# INTEGRATED PLANNING ACT NEGOTIATED DECISION NOTICE

# **Development Application**

**Proposal** : Reconfiguring by subdivision three (3) standard format lots

Site Address : Mitre Street, Port Douglas

Dute Journage Congress A-TP-06

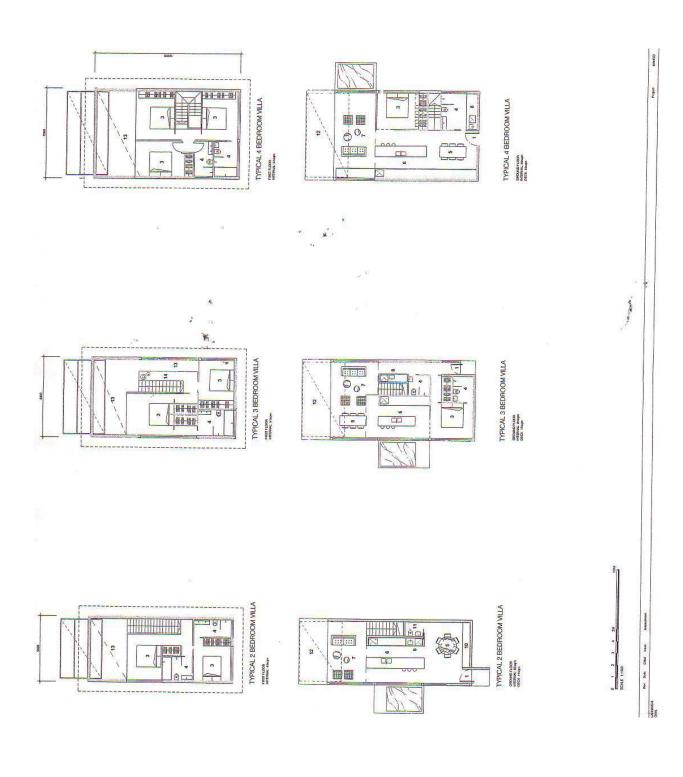
- 1. The approved development and the carrying out of any works on the premises associated with the development must generally be in accordance with Plans of Development numbers A-TP-02 to A-TP-05 Rev 1 attached to this approval, subject to:
